ADDENDUM ONE

Project: **Sullivan County Schools East High School S.T.E.M. Classroom Renovations**

October 26, 2023

COVER SHEET

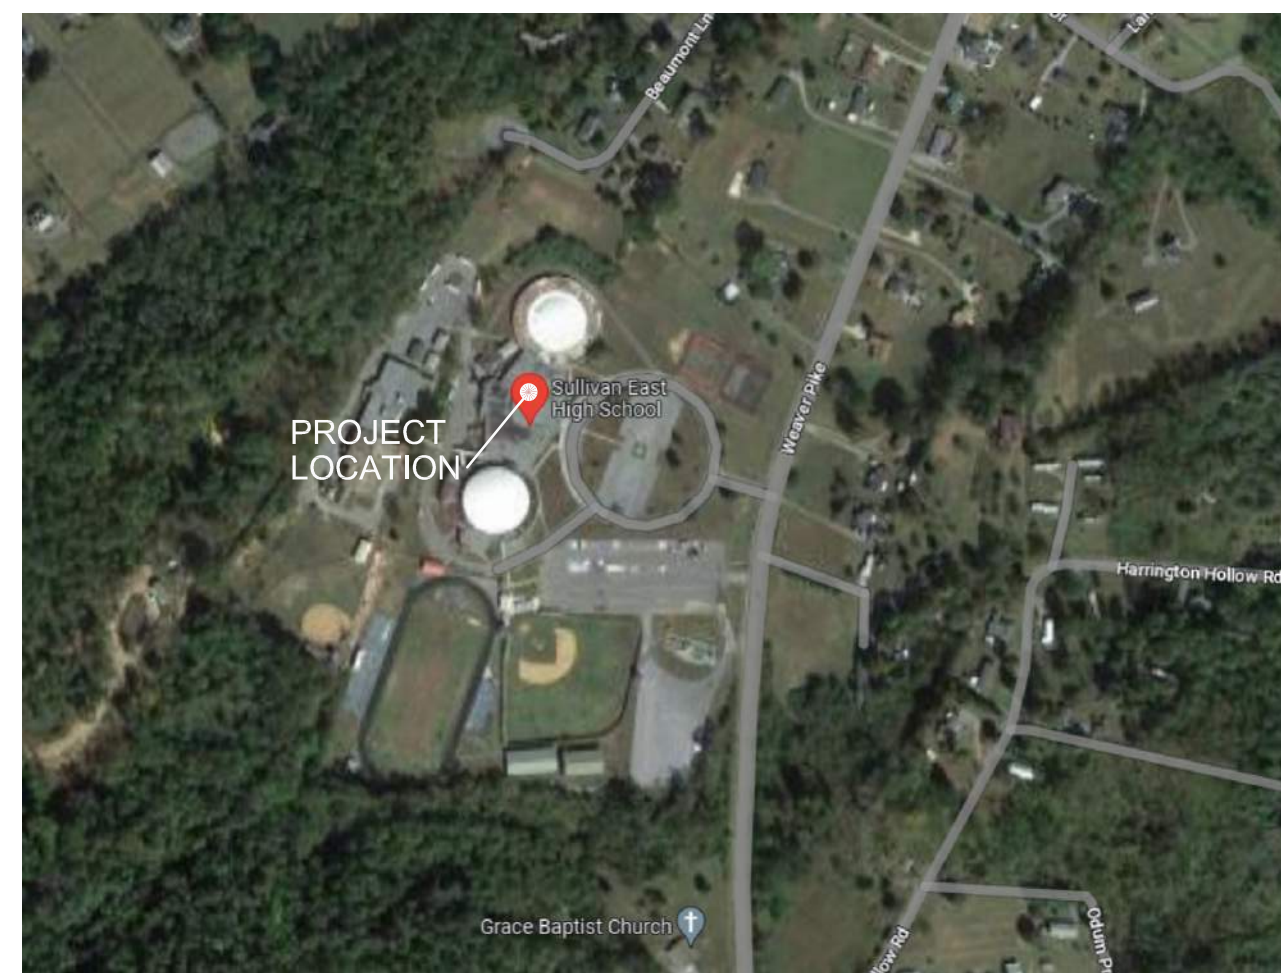
1. **DRAWING G-00** – Revised Drawing Index
2. **DRAWING G-01** – Revised Code Data
3. **DRAWING A-10** – Revised to include Alternate #1 (LVT Flooring) and Alternate #2 (Wall Painting).
4. **DRAWING MP-1.0** – Duct detector clarification. See note 5 for integration with existing building control system.
5. **DRAWING MP-1.1** – See inclusion of penetration firestopping.
6. **DRAWING E-01** – Drawing provided with Engineers Seal, no other revision.
7. **DRAWING E-11** – Drawing provided with Engineers Seal, no other revision.
8. **DRAWING E-12** – See inclusion of Fire Alarm Notes
9. **DRAWING E-21** – Drawing provided with Engineers Seal, no other revision.
